RE: 289 Marchmont Drive

I reviewed the drawings and evaluated the site context. My comments and recommendations are as follows:

EXHIBIT 4

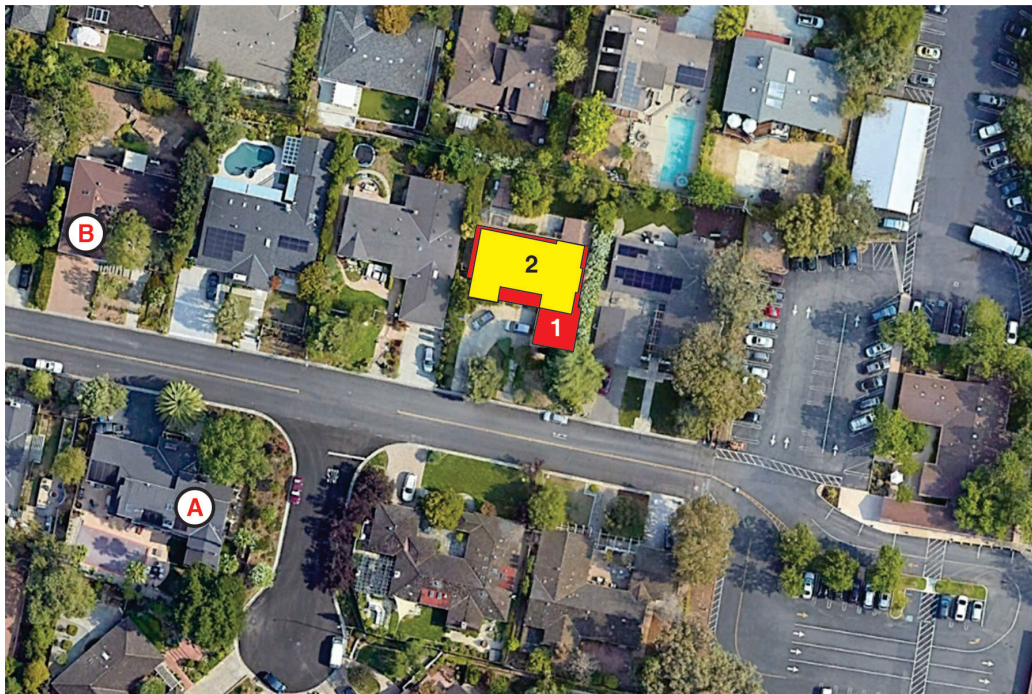
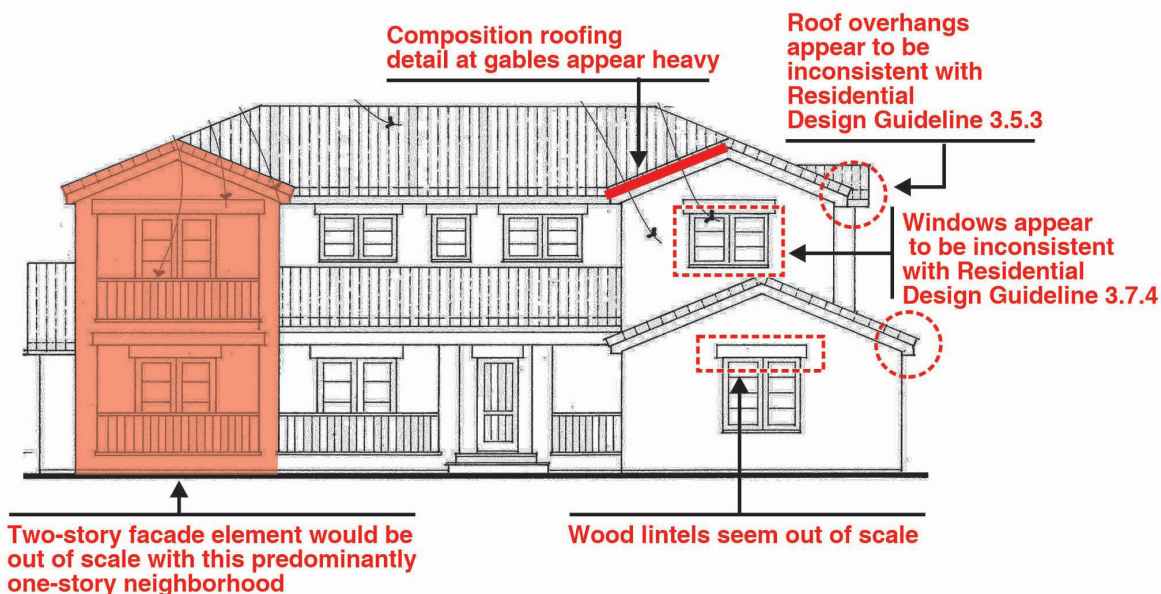
1. The two-story house would be visually taller, with more building mass than is common for the neighborhood.
2. There are only two homes nearby that have a second story, and those have mitigating measures to minimize their visual bulk in order to blend in with the adjacent predominantly one-story homes. The two-story balcony element on the front facade would be especially out of character and scale with this neighborhood - see air photo, streetscape, two-story home photos and front elevation illustrations below.

3. Wood lintels over windows and doors are acceptable for this architectural style, but those shown on the drawing look too large and out of scale with the size of this house.
4. The drawing do not appear to show deep recessed windows or trim around the windows which would not be consistent with Residential Design Guideline 3.7.4.

5. The roof overhangs appear small which would not be consistent with Residential Design Guideline 3.5.3.

6. The roof is noted as composition shingle, but the drawing show roof edges that appear more consistent with tile roofs.

1. Remove the second floor porch roof cover and columns.
2. Increase all roof overhangs to be similar to the predominant roof details in the immediate neighborhood.
3. Recess all windows or add wood trim to be consistent with Residential Design Guideline 3.7.4.
4. Reduce the depth of lintels over the windows and doors.
5. Refine the roof edge details.
